### **KEWAUNEE POWER STATION IMPROVED TECHNICAL SPECIFICATIONS CONVERSION**

#### **ITS SECTION 3.0 LCO AND SR APPLICABILITY**

##### **Revision 0**

**Current Technical Specification (CTS) Markup  
and Discussion of Changes (DOCs)**

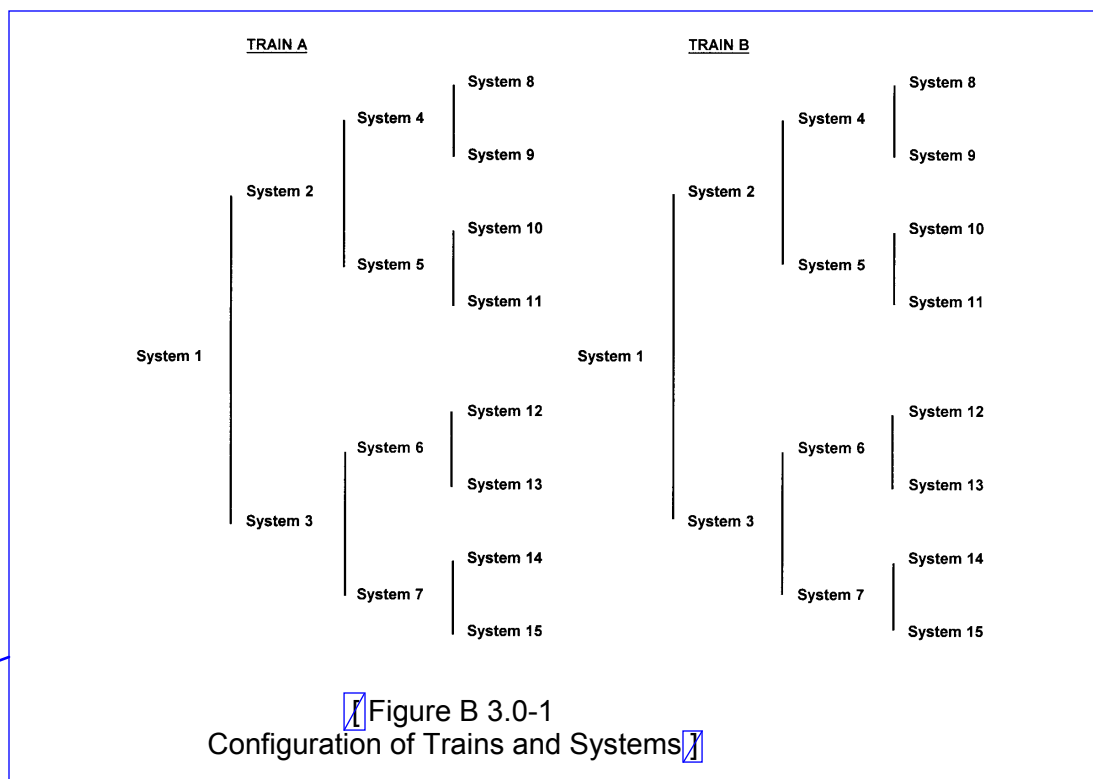
3. The ISTS Figure B 3.0-1 is located within the text portion of LCO 3.0.6. The typical configuration for locations of figures is at the end of the applicable section. The figure is relocated to the end of the LCO section for 3.0. This is acceptable since the relocation of the figure to the end of the section is in accordance with the format of the ITS.

7. The following fixes to incorrect statements for the examples in the LCO 3.0.6 Bases have been made. Specifically:
  - 1) Example B 3.0.6-1 is changed from "If System 2 of Train A is inoperable and System 5 of Train B is inoperable, a loss of safety function exists in supported System 5" to "If System 2 of Train A is inoperable and System 5 of Train B is inoperable, a loss of safety function exists in Systems 5, 10, and 11." Examining Figure B 3.0-1, it is clear that if there is a loss of safety function in System 5, there is also a loss of safety function in the systems supported by System 5, i.e., Systems 10 and 11. This relationship is explicitly listed in Example B 3.0.6-3 and to not do so here is inconsistent and confusing as it leads the reader to believe that Systems 10 and 11 do not have a loss of safety function. Furthermore, System 5 of Train B is not a supported System of System 2 of Train A, since they are in different trains. Thus, the word "supported" has been deleted.

Kewaunee Power Station needs to make these changes since the current wording in the ISTS 3.0.6 Bases are not correct. Furthermore, these changes are consistent with industry approved TSTF-494T.
